STATE OF MAINE  
DEPARTMENT OF TRANSPORTATION  
16 STATE HOUSE STATION  
AUGUSTA, MAINE 04333-0016

February 2, 2023  
Subject: Acadia Gateway  
State WIN: 017163.03  
Location: **Trenton**  
**Amendment No. 7**

Make the following changes to the bid documents:

**8 TYPICAL CURTAINWALL SILL DETAIL AT GRADE**  
3"=1'-0" 0 3" 6"

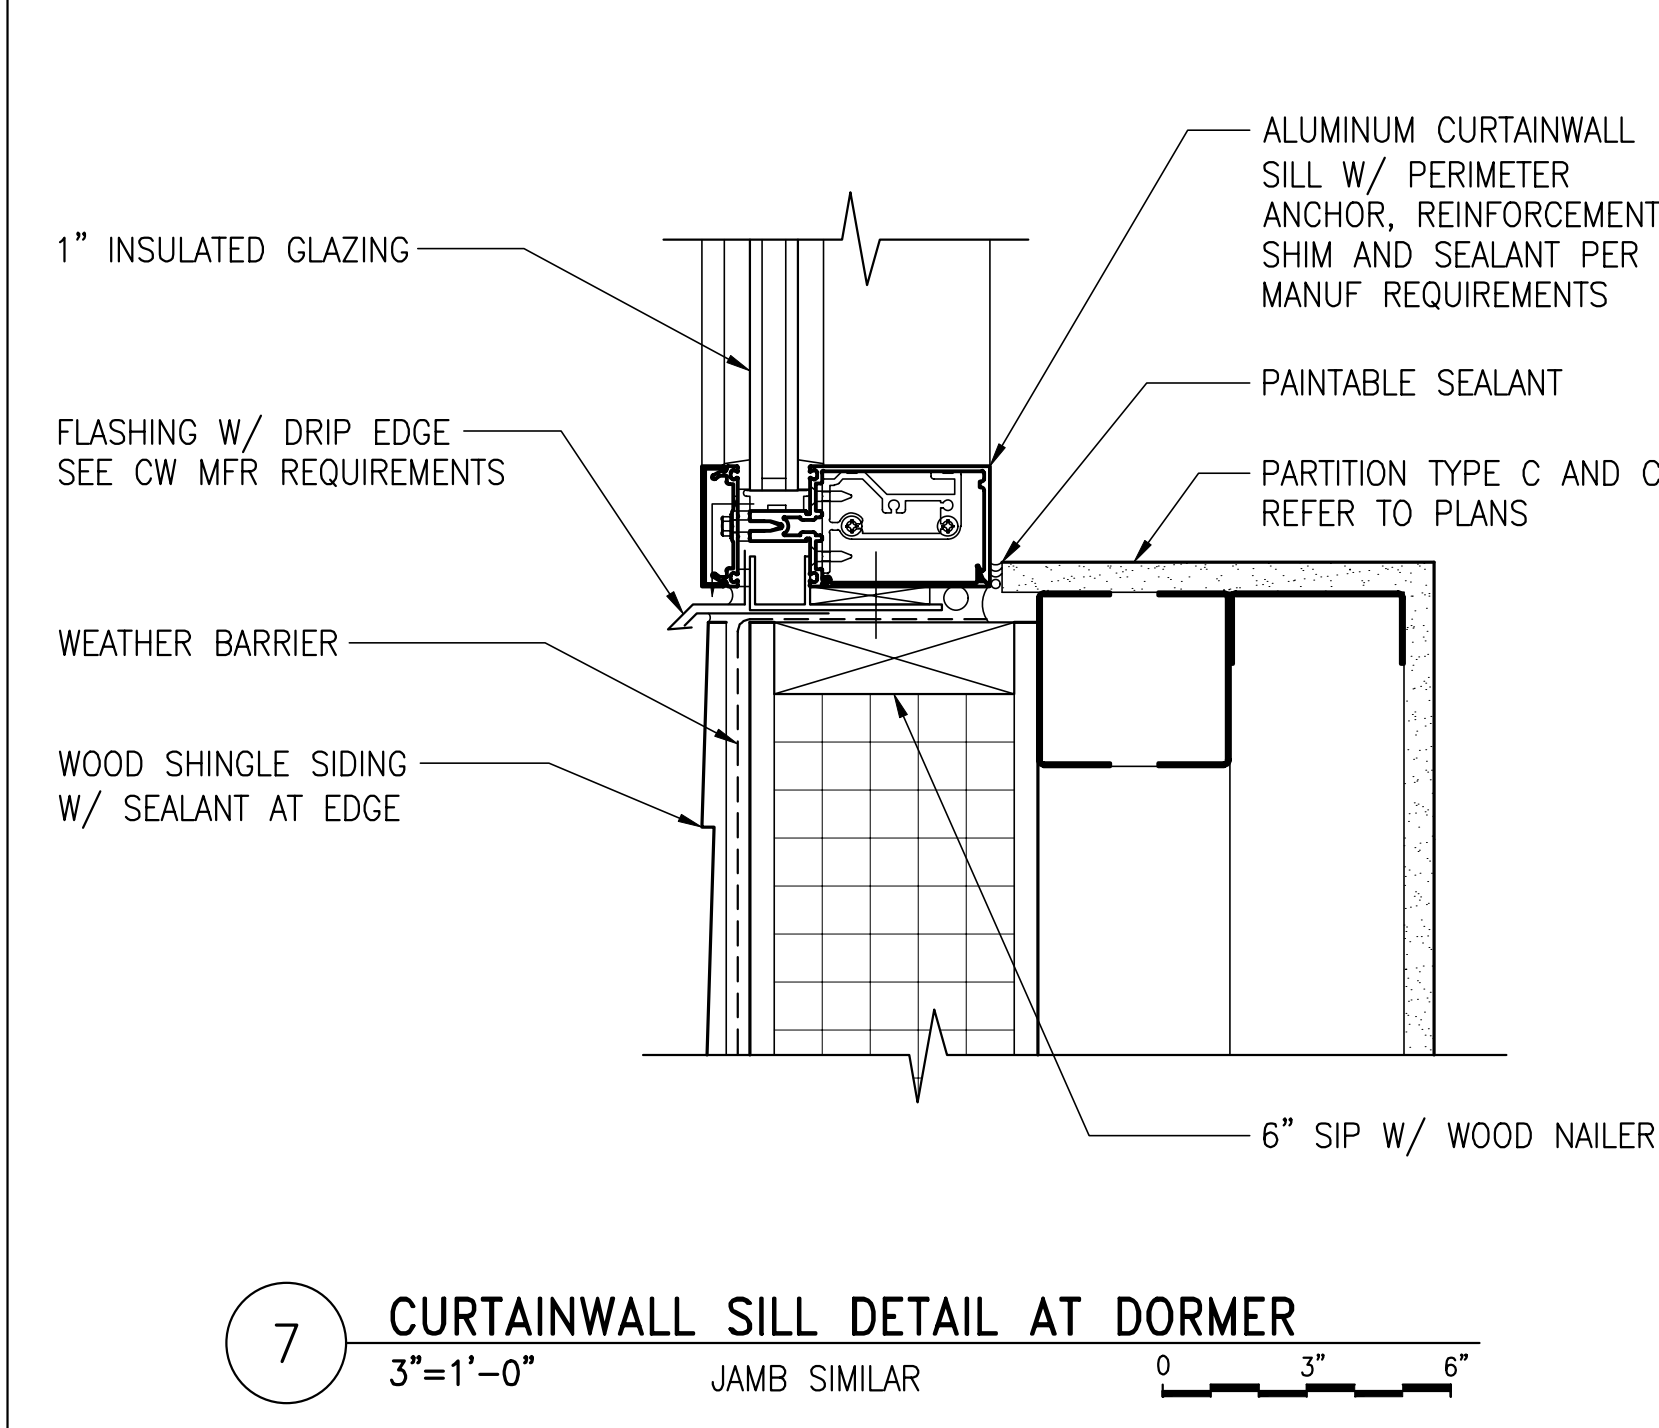
**Question:** Drawing A816 detail 2,3,4 & 8 indicate a stone interior sill. It is graphically shown smooth with a bullnose. The specified stone is rough. Please confirm the sill material and its finish

**Question:** Drawing a816 detail 2,3,4, & 8 indicate a stone interior sill. It is graphically shown smooth with a bull nose. The specified stone is rough. Please confirm the sill material and its finish

**Response:** This information was provided in Amendment #6.

**Response:** This information was provided in Amendment #6.
